# HAY CREEK VALLEY

## FINAL DRAINAGE REPORT

EPC STORMWATER REVIEW COMMENTS  
IN ORANGE BOXES WITH BLACK TEXT

Project No. 22.886.076

Figure 6- Q100 OUTFALL SUMMARY

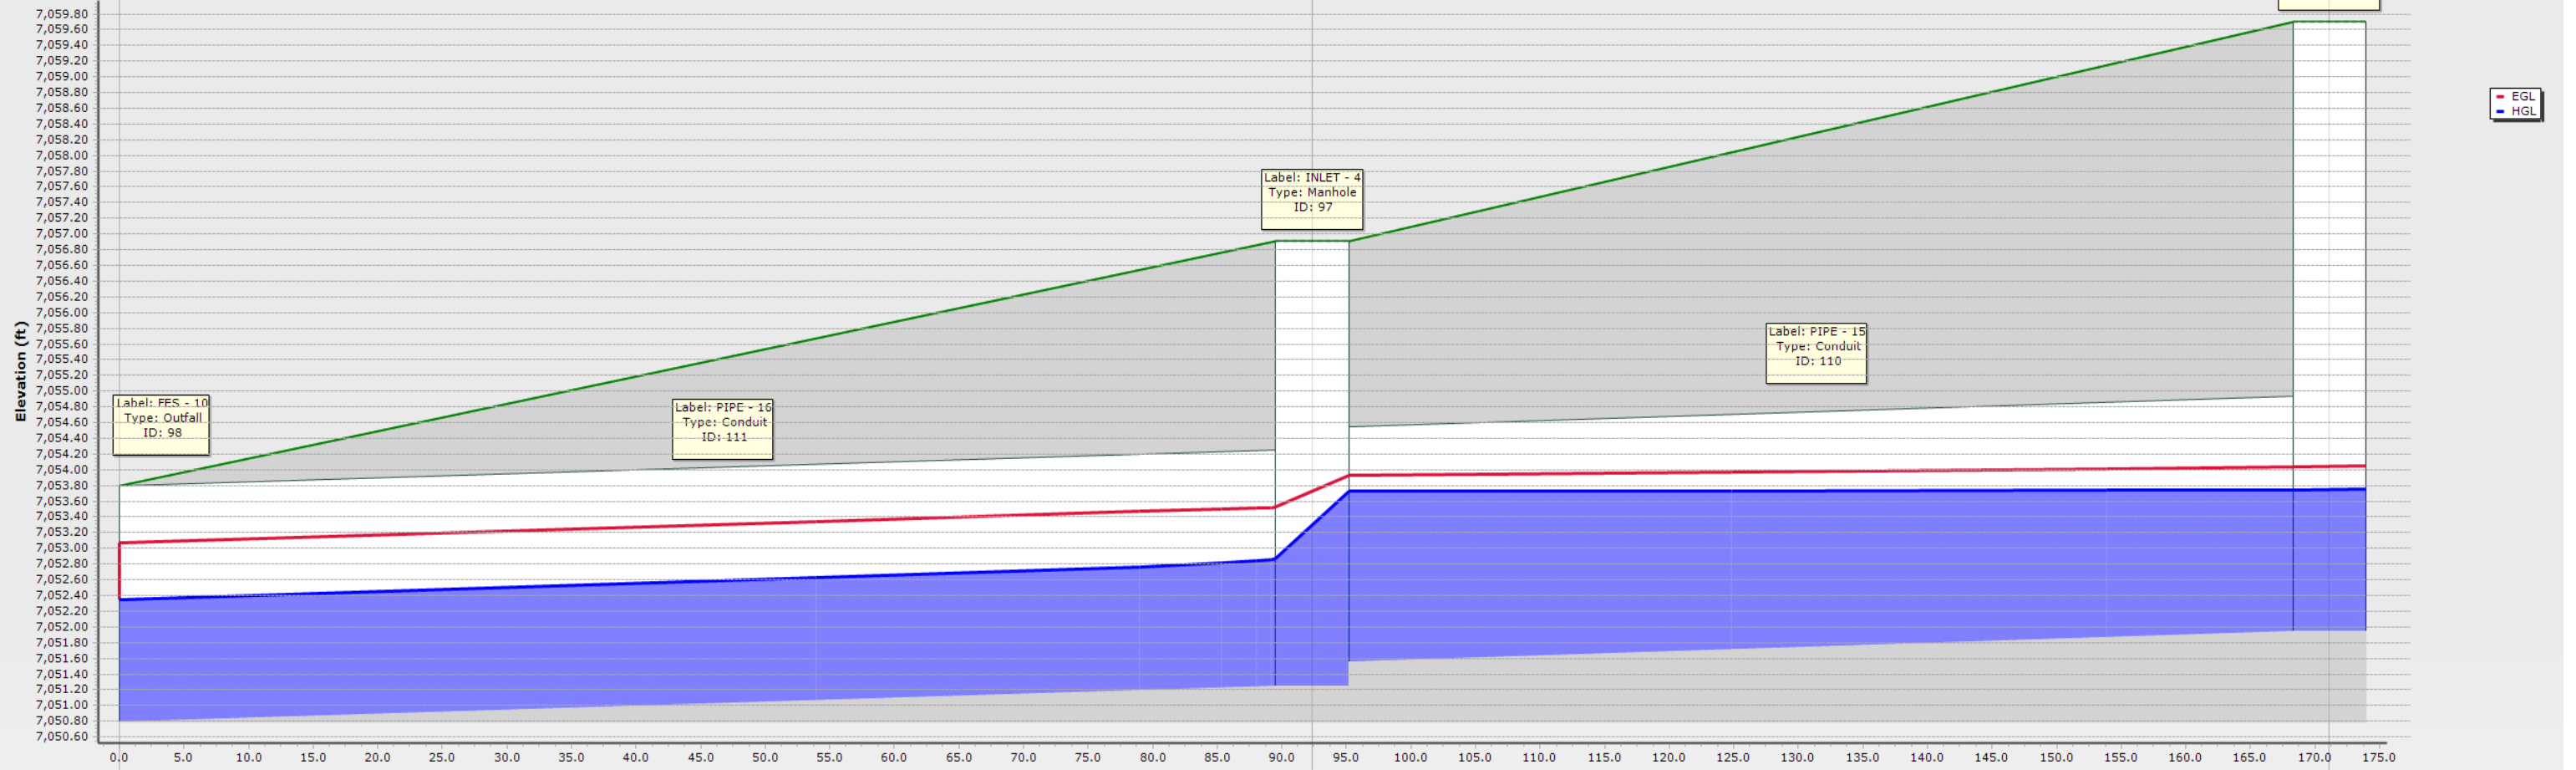
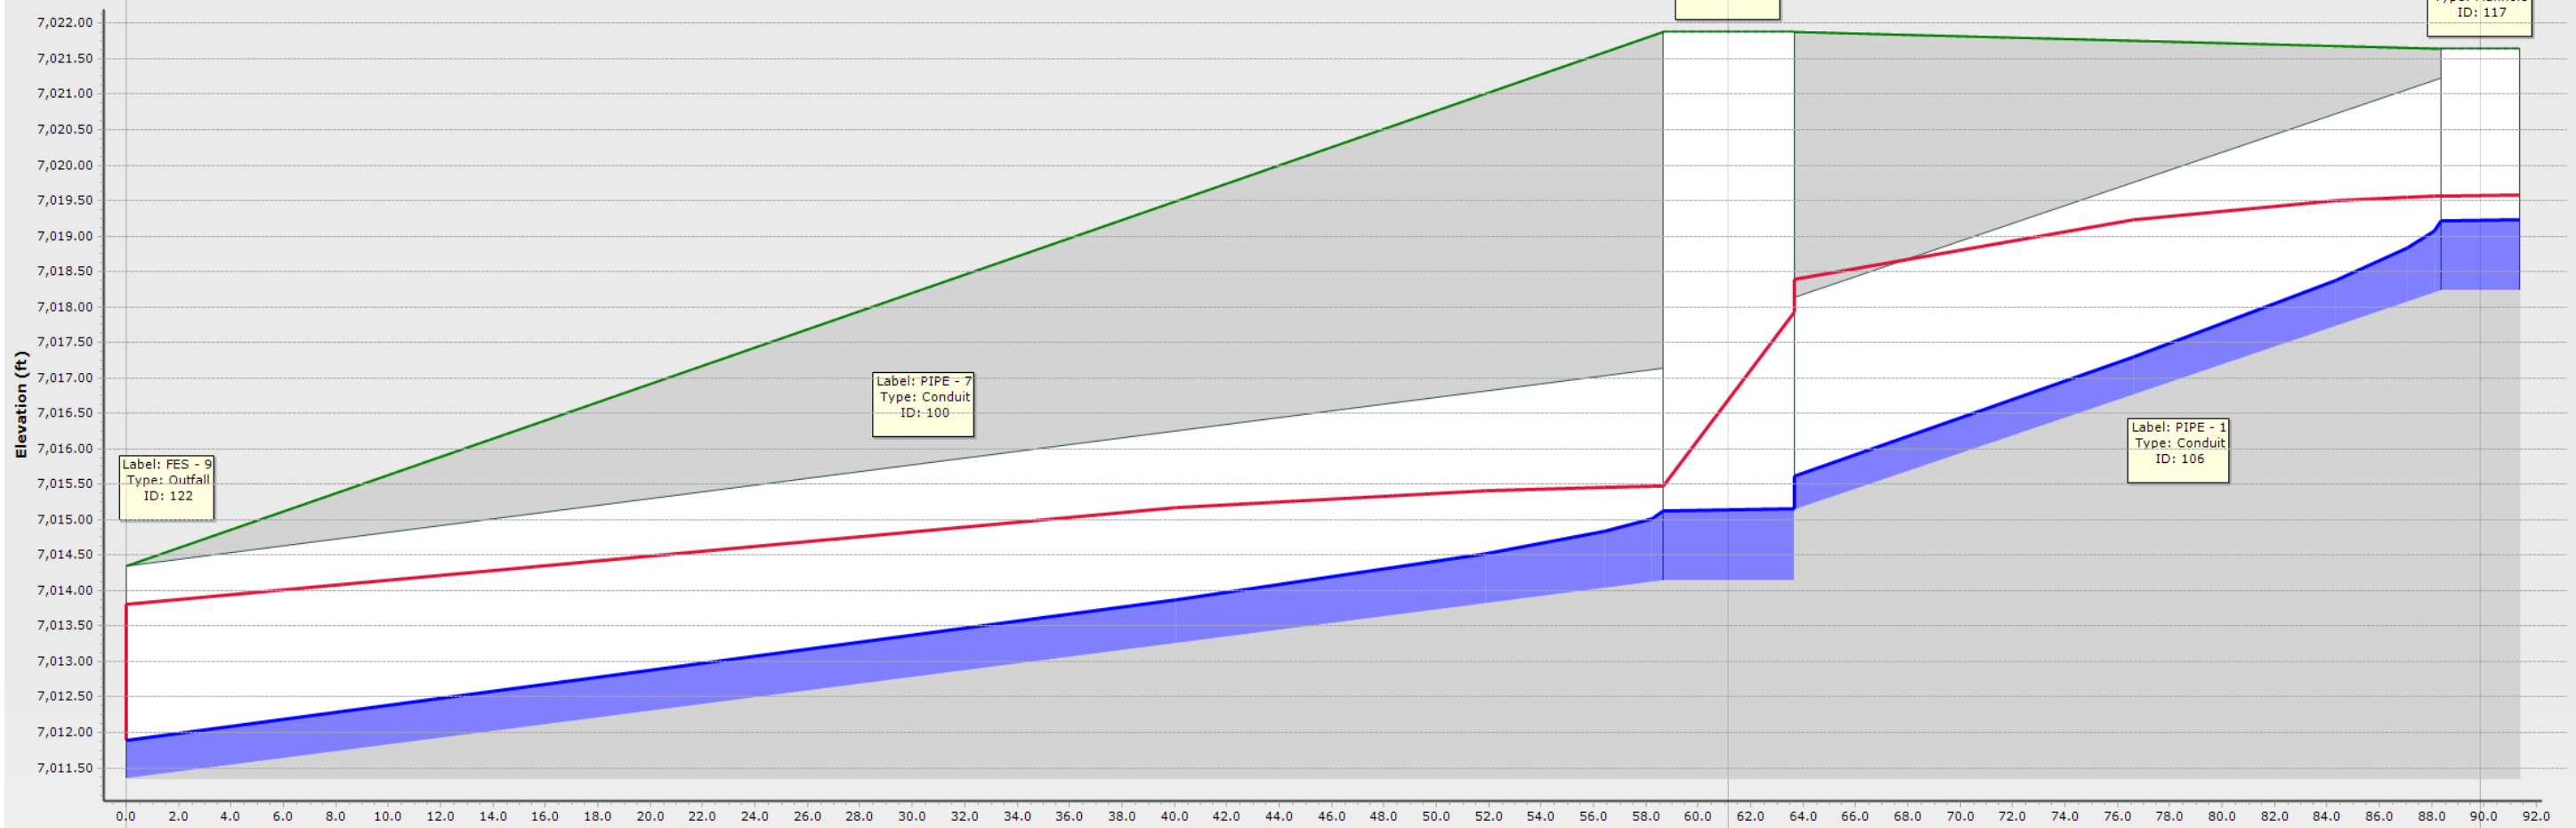
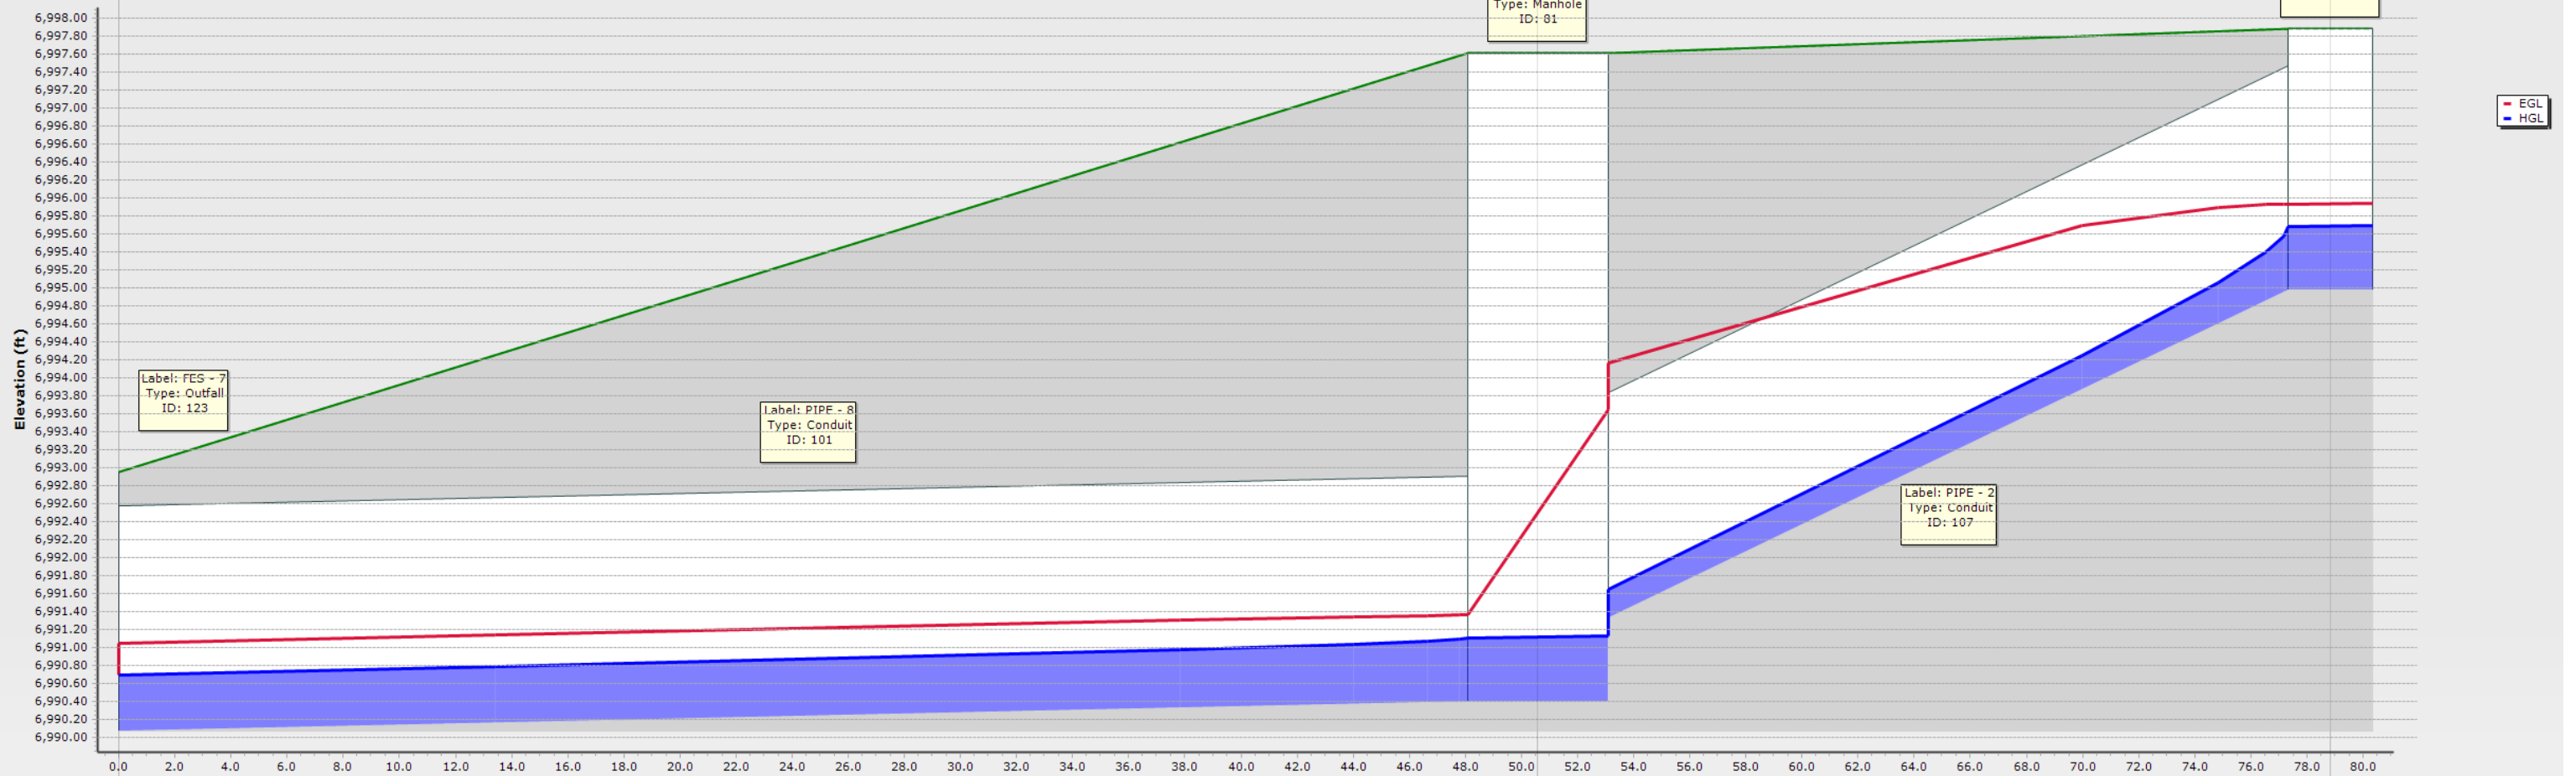
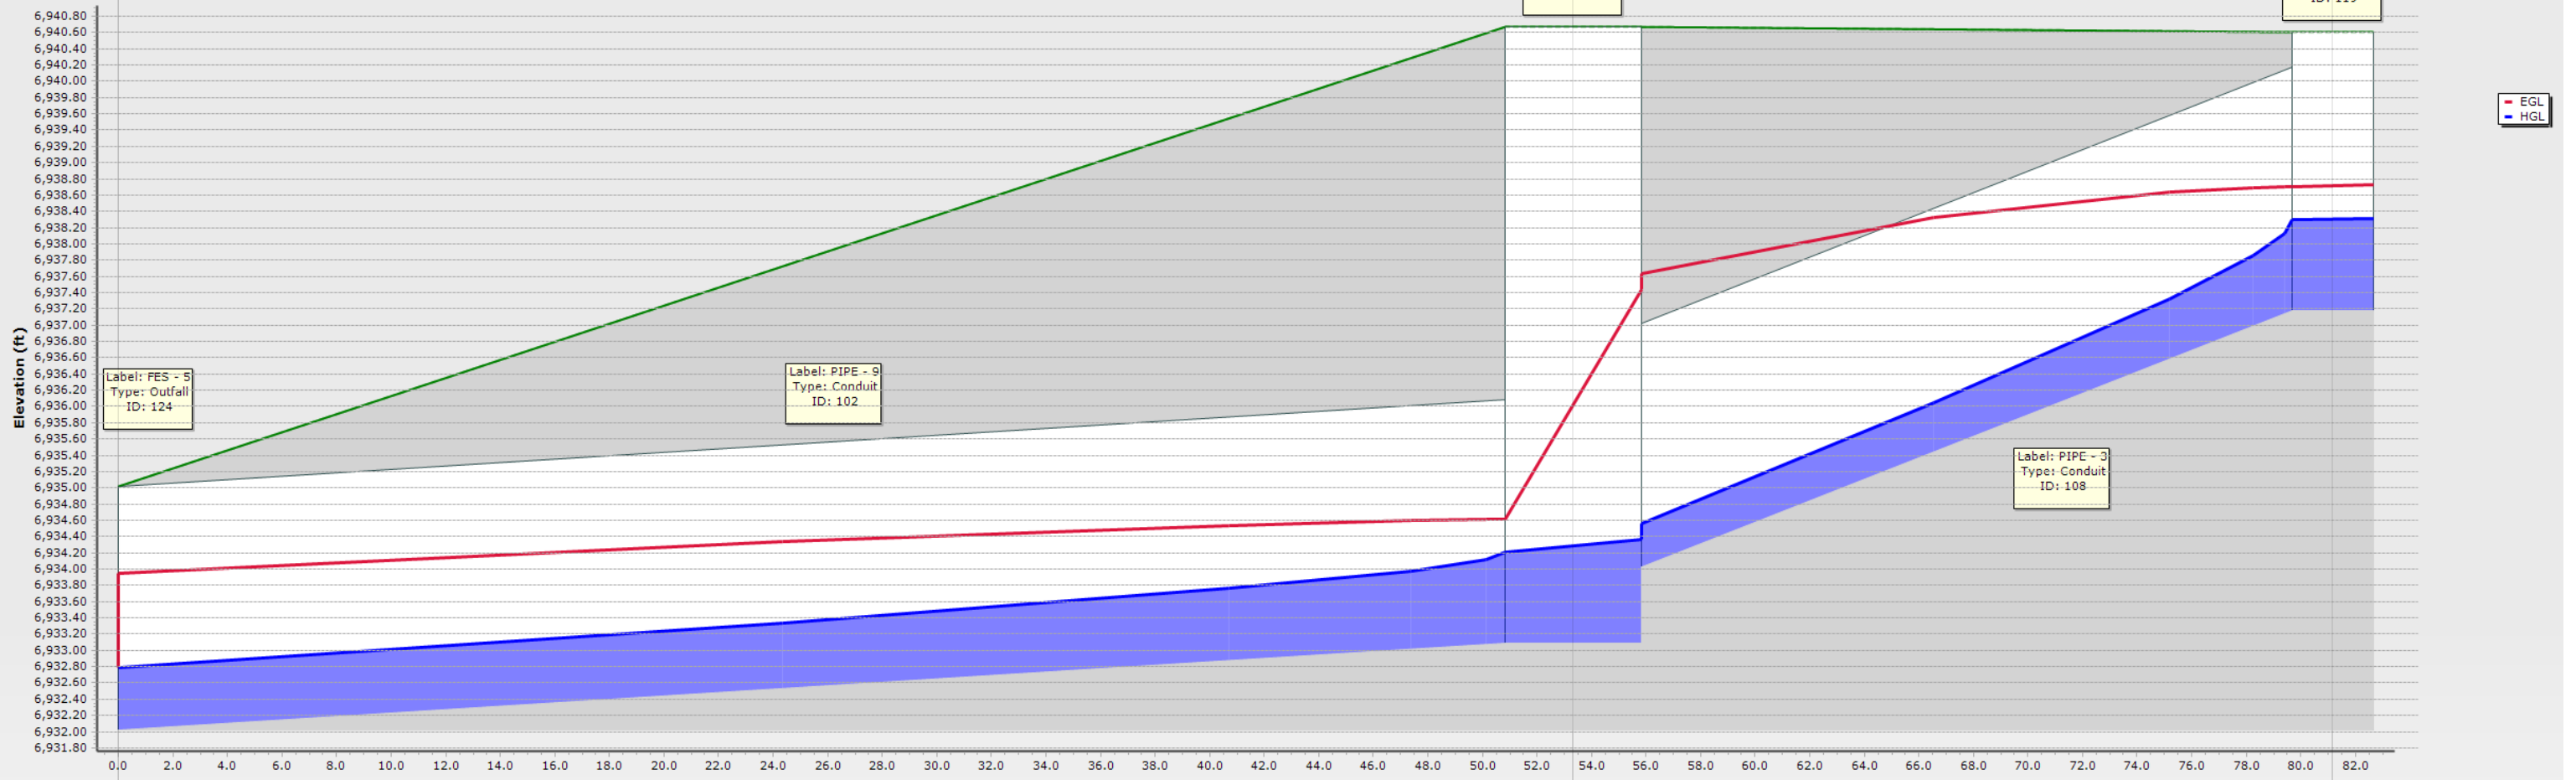
why is free outfall selected and tailwater is not analyzed for 6 of the 7 storm drain outfalls? If there's a reason please add a note/discuss.
